# Response to NT EPA Direction to provide additional information #2

## Australia-Asia Power Link Environmental Impact Statement

**March 2024**

Ecoz Job	EZ24025
Document ID	234882-8
Author(s)	Glen Ewers and Alice Nichol (EcOz Environmental Consultants) Jamie Castles and Kylie Welch (SunCable)

Figure 1  
Sun Cable  
Australia-Asia PowerLink Project

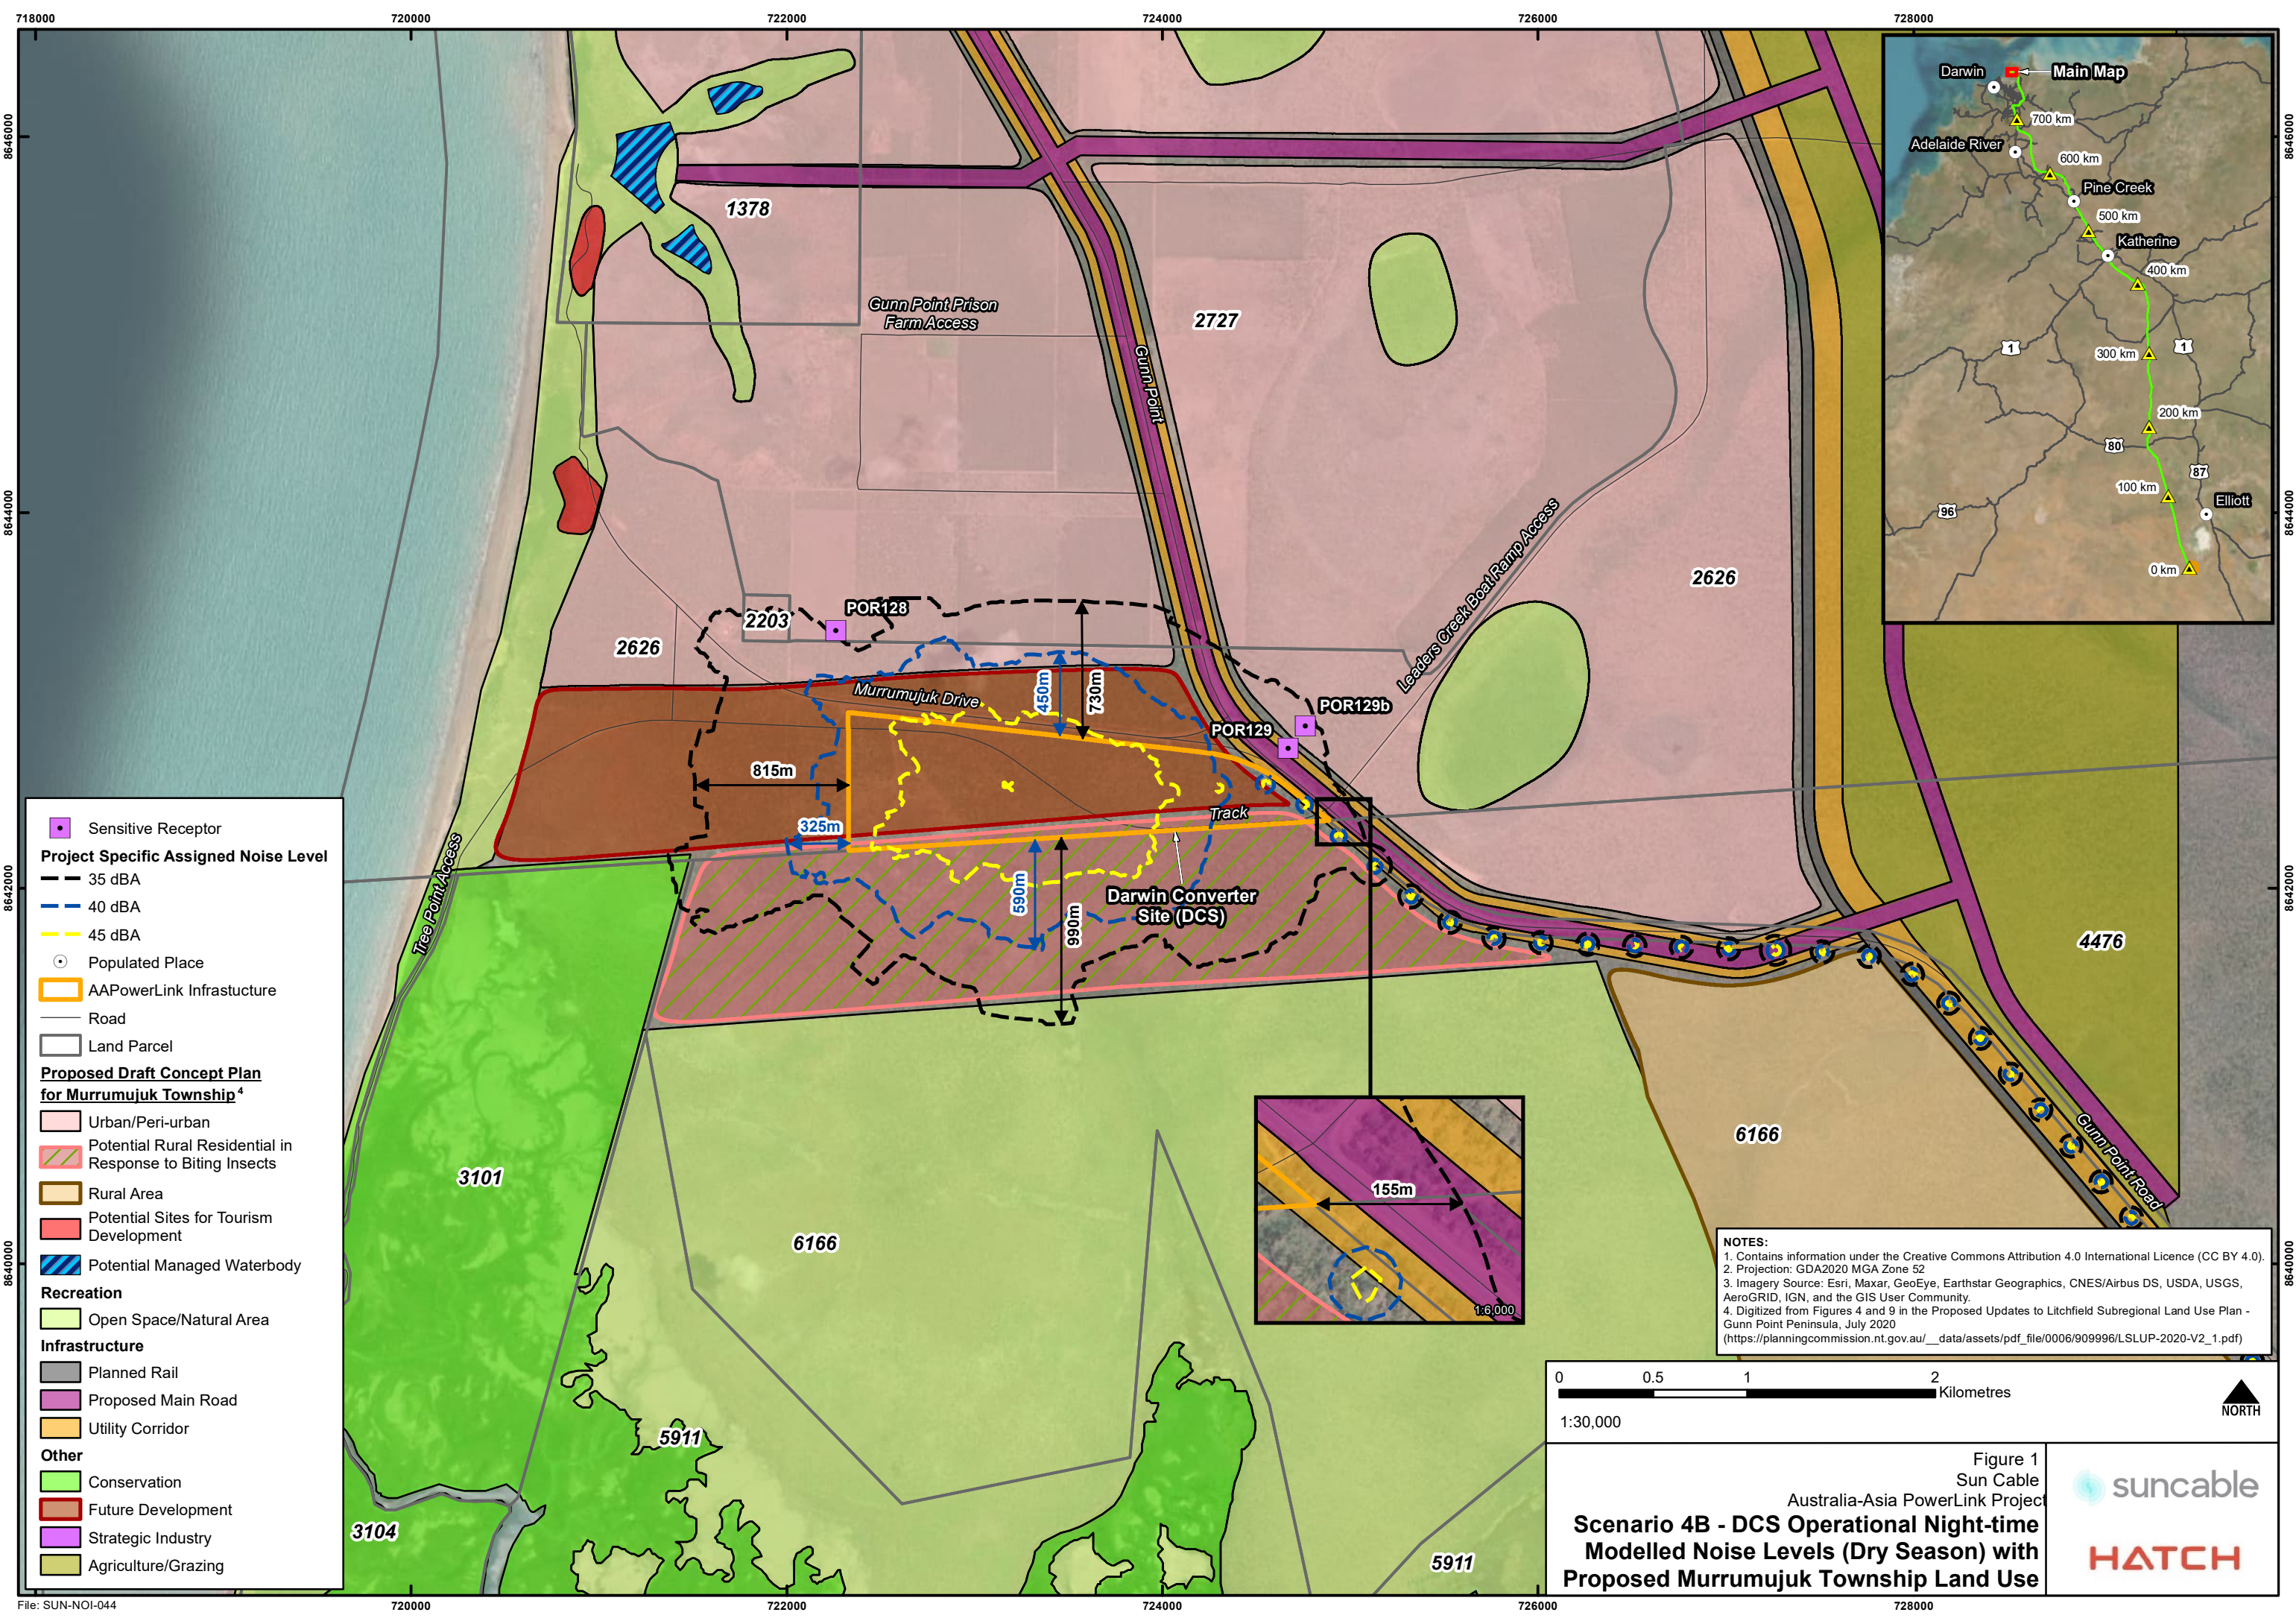
2. Provide revised noise model outputs for the Darwin converter site with all proposed mitigation measures in place. Demonstrate compliance with the Northern Territory noise management framework guideline (2018), specifically in relation to the noise-sensitive residential and rural residential land uses identified for the Murrumujuk Township within the proposed updates to the Litchfield Subregional Land Use Plan.

The modelling results for Scenario 4B indicate noise impacts from the DCS can be almost fully mitigated. Scenario 4B contains only one sending VSC shifted approximately 200 m south from the original location designated in the concept design. The BESS is shifted approximately 400 m west and 90 m south to tie into the relocated VSC. At source mitigation (enclosures/shielding) is placed on the inverters, battery, and transformer skids. In addition, a 7m tall 3-sided concrete/brick walled bunker is added to the VSC transformers and step-up transformer. With these mitigation measures in place the noise model outputs show very marginal exceedances of the 'Urban' and 'Rural' noise levels over the future urban/peri-urban land use zones.

As Figure 1 shows, considering the 'Rural' (35 dBA) noise limit, increased noise levels are predicted to extend locally from the DCS property boundary for approximately 730 m to the north, 155 m to the east, 990 m to the south and 815 m to the west until the 35 dBA limit is met. The affected area is almost halved when considering the 'Urban' 40 dBA limit; the impact extends locally for 450 m to the north, 590 m to the south, and 325 m to the west, with no impacts to the east of the site – see Figure 1. Table 5 summarises the area of the 'urban/peri-urban' residential land use zone and 'potential rural residential' land use zone potentially affected by noise levels that exceed the noise limits set in accordance with the *NT Noise Guidelines*.

**Figure 2. Alternative OHTL routes assessed to avoid potential impacts to Ghost Bats**

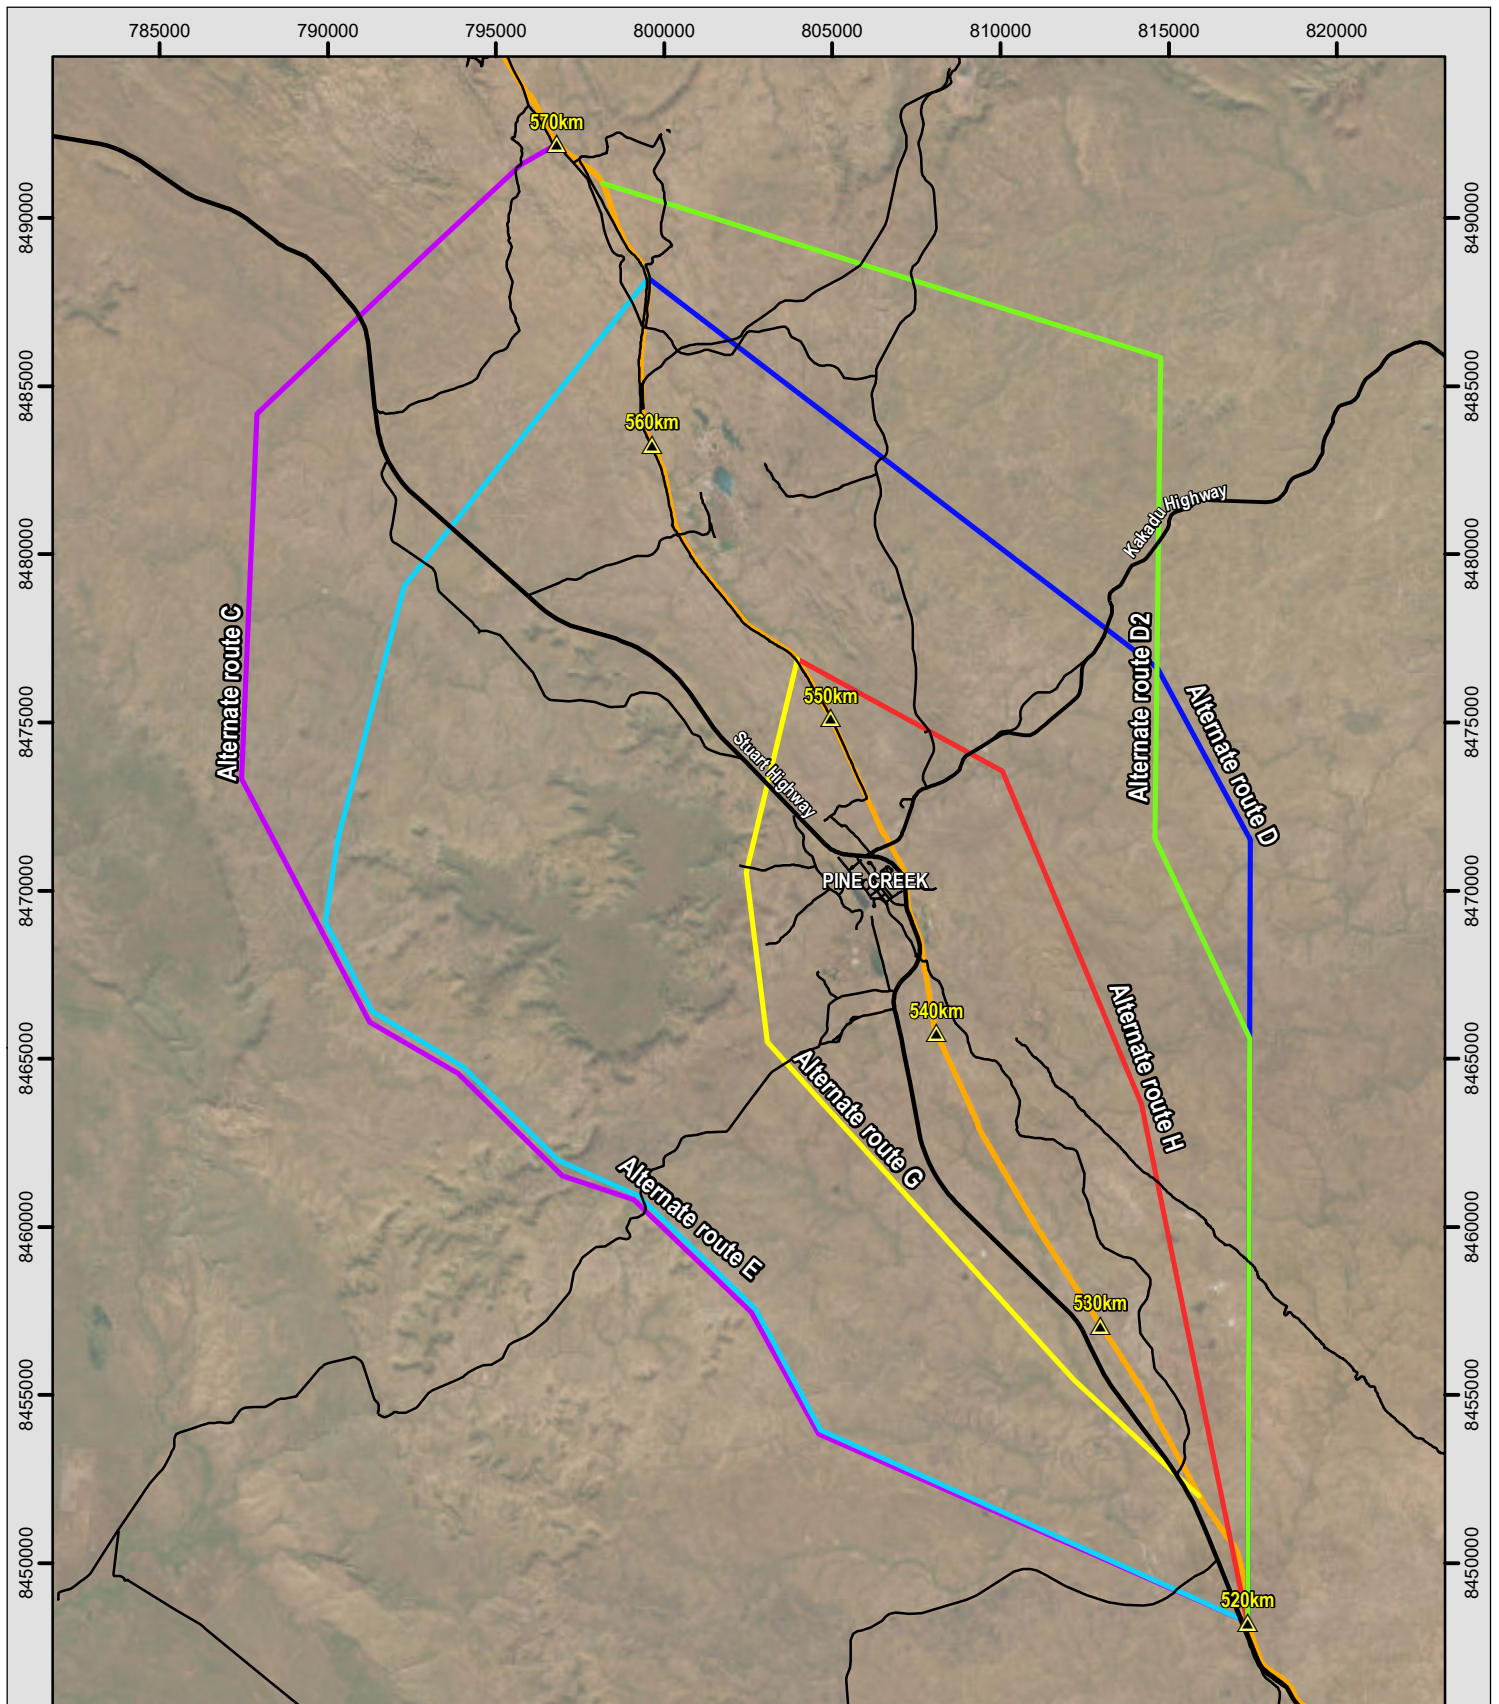
2. Compare the selected measures and alternatives and provide reasons for selecting or not selecting each. If an option is not selected because it was considered not economically feasible, a comparison of the environmental effectiveness of the options must still be included.
3. Demonstrate how the environment protection and management measures (Part 2 of the EP Act – including the precautionary principle) have been applied. Include an evaluation of how serious or irreversible harm to Ghost Bats has been avoided to the maximum extent practicable. Provide an assessment of the risk weighted consequences of various management options.
4. Discuss any expected potentially significant residual impacts and proposed offsets.

The routes considered are shown on Figure 2 and are located between approximately 4 km and 13 km from the Kohinoor adit with options both to the east and west of the existing route and Pine Creek. Routes further away were not identified as they were considered by the project team to present a very high level of project risk due to those areas having not been surveyed, and there being no engagement with landholders and other stakeholders in those areas to date. Further, the best available data in relation to Ghost Bat movements provided in DEPWS (2023) indicates that while the bats do fly long distances, most movements are within 10 km from the roost (as further discussed below), and therefore this distance was considered to provide a precautionary approach to minimising the potential for impacts.

Routes C and E to the west of Pine Creek, while achieving a greater level of separation from the Kohinoor adit (up to 13 km), are considered challenging because they are constrained by topography, have a higher potential for encountering sacred sites and archaeological heritage sites associated with hilly terrain, and landowners in this area have not been engaged as their properties are not affected by the existing preferred route. For these reasons the routes to the west are not preferred by SunCable.

Route H, 4 km to the east of the adit, was initially identified as SunCable's preferred alternative. This route achieves a greater separation from the adit than the current preferred route, limits impact on landowners to the greatest extent practicable and does not impact other known environmental or heritage values. However, early feedback received from the DEPWS on this route indicated that the separation distance achieved from

Route D2 was selected as the most 'acceptable' alternative route. This route departs the railway corridor south of Pine Creek, traversing east/north-east across predominately pastoral land to provide an 8-10 km buffer to the Kohinoor adit, before rejoining the railway corridor. The aim of this route was to avoid disturbance within 10 km of the roost based on the above-mentioned data that suggests this is where most Ghost Bat foraging occurs. Total avoidance was not able to be achieved without crossing an additional property and therefore the route skirts around the edge of property boundaries attempting to achieve a balance between limiting the number of landholders affected, limiting impacts on affected landowners, and maximising the distance of the OHTL from the Kohinoor adit. The desktop assessment presented at Appendix D indicates that this route does not intersect any known environmental or heritage values, and therefore is unlikely to increase the level of impact when compared to the existing preferred route put forward and assessed in the SEIS.

**Figure 3. Map of potentially impacted Ghost Bat foraging habitat**

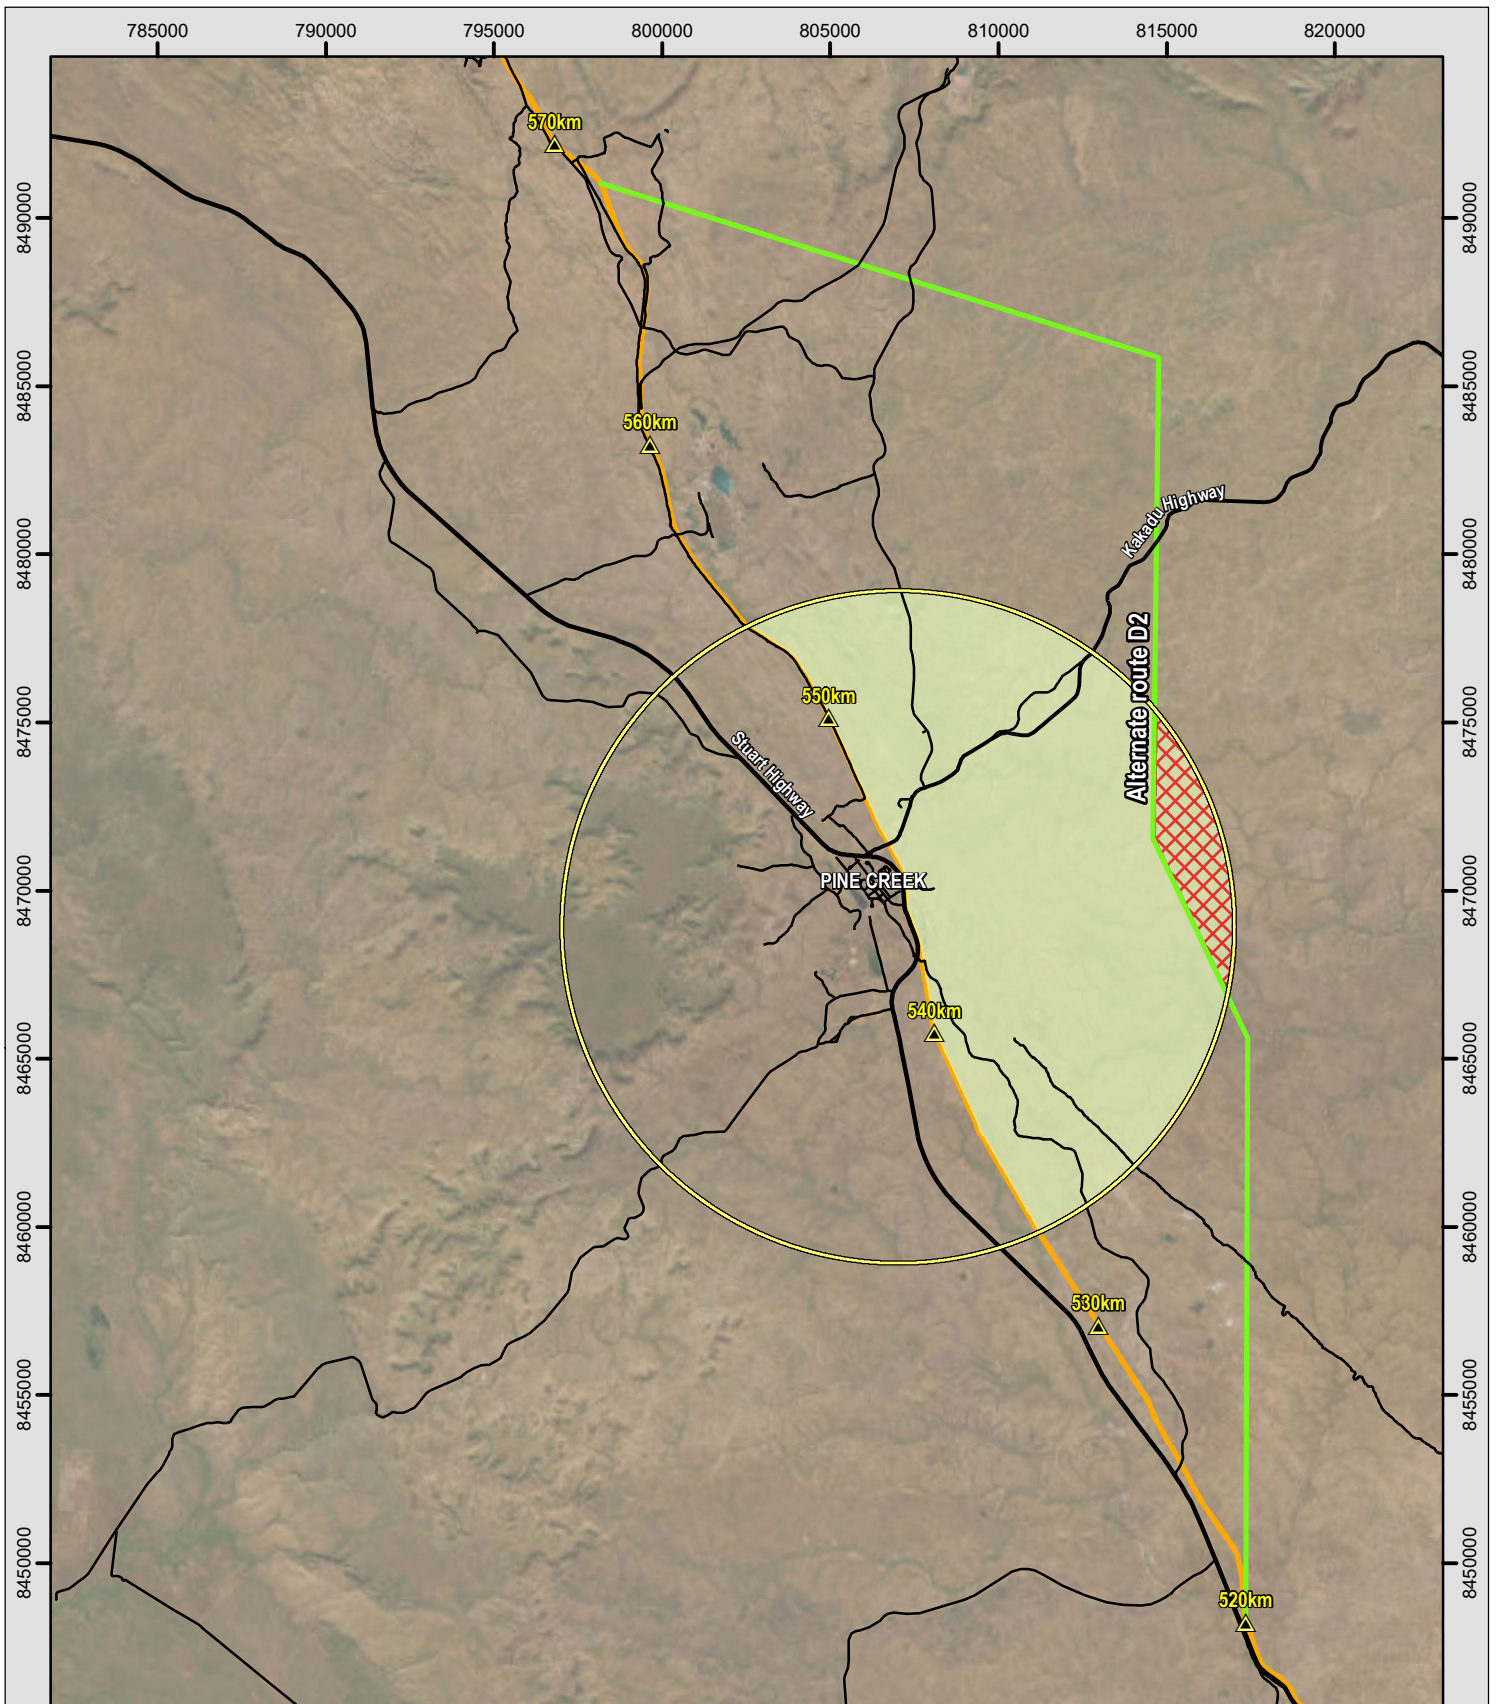
- did not provide avoidance/ mitigation approaches nor any substantial discussion about the effectiveness and confidence in the measures and any residual significant impacts as per item 8(4) of the NT EPA's Direction.
- has not demonstrated how the precautionary principle was applied (as per item 8(5) of the NT EPA's Direction).
- has not adequately demonstrated that the OHTL alignment will not have unacceptable impacts on the globally-important Kohinoor Adit specifically, and on Ghost Bats in both the Pine Creek and Katherine regions more generally.

As directed, SunCable has moved the OHTL further away from the Kohinoor adit. The alternative route (D2) increases the distance between the OHTL and the Kohinoor adit complex from 395 m at its closest point, to 8,015 m at its closest point (see Figure 2). This route deviation also increases the distance between the OHTL route and the Union Reef adit complex from 1,410 m at its nearest point to 6,380 m. The distance between route D2 and the other important roost complex in the region, Spring Hill, remains the same as the previous route at 1,041 m.

Assuming that foraging mainly occurs within a 10 km radius circle centred on Kohinoor adit complex, the location of the alternative route D2 could isolate up to 3.3 % of the main foraging area. This is significantly less than the previously preferred route, which could isolate 48.4 % of the main foraging area. The location of both the existing preferred route and alternate route D2 in relation to the main foraging area around the adit are shown in Figure 3.
